Access Compliance Report Public Rights-of-Way (Curb Ramps)

Main Street: MEANDERING TRAIL		Cross Street: CASTLETREE		Location:	SW
ADA ID: RPRK211018153215	Ramp Type: Type 1 - Perpendicular	Initial Pass/Fail: Fail	Overall Compliance: No	Severity Score:	15
Codes/Mitigation Info/Possible Solution			Field Measurements/Component Compliance

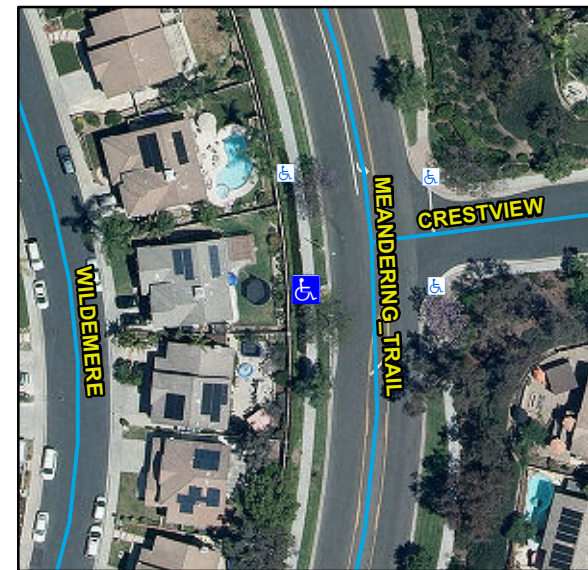
Compliance	Description	Data	Compliance	Description	Data
N/A	Ramp Length (in)	78	N/A	Flare Type LT	
Yes	Ramp Width (in)	48			N/A
No	Ramp Run Slope (%)	11.8	N/A	Flare Slope LT (%)	N/A
Yes	Ramp Cross Slope (%)	1.6	N/A	Flare Traversable LT	N/A
N/A	Landing Present	N/A	N/A	Flare Type RT	
N/A	Landing Length (in)	N/A			N/A
N/A	Landing Width (in)	N/A	N/A	Flare Slope RT (%)	N/A
N/A	Landing Run Slope (%)	N/A	N/A	Flare Traversable RT	N/A
N/A	Landing Cross Slope (%)	N/A	N/A	DWS Provided	N/A
N/A	Landing Movement Obstructed?	N/A	N/A	DWS Contrast	N/A
	Landing Movement Type	N/A	N/A	DWS Length (in)	N/A
N/A	Landing Shared	N/A	N/A	DWS Full Width	N/A
N/A	Clear Space	N/A	N/A	DWS Offset Left (in)	N/A
N/A	Clear Space To Crosswalk (in)	N/A	N/A	DWS Offset Right (in)	N/A
N/A	Marked Crosswalk 1	No	N/A	Marked Crosswalk 2	N/A
	Crossing 1 Direction	E		Crossing 2 Direction	N/A
	Marked Crosswalk 1 Width (in)	N/A		Marked Crosswalk 2 Width (in)	N/A

N/A	Ramp Inside Crosswalk 1	N/A	Yes	Ramp Inside Crosswalk 2	N/A
	Crossing 1 Slope (%)	3.8		Crossing 2 Slope (%)	N/A
	Crossing 1 Cross Slope (%)	3.8		Crossing 2 Cross Slope (%)	N/A
N/A	Gutter Ponding	N/A	No	Curb Slope	6.9
Yes	Gutter Lip Height (in)	0		Road Run Slope (%)	N/A
N/A	Gutter Run Slope (%)	N/A		Road Cross Slope (%)	N/A
N/A	Gutter Cross Slope (%)	N/A			
Yes	Overall Surface Condition: Acceptable		No	Perp Joint Present	No
	Cross Gutter Present?	No		Spandrel Present?	No
	Replace Cross Gutter?	N/A		Replace Spandrel?	N/A

Remove & Replace Entire Ramp.
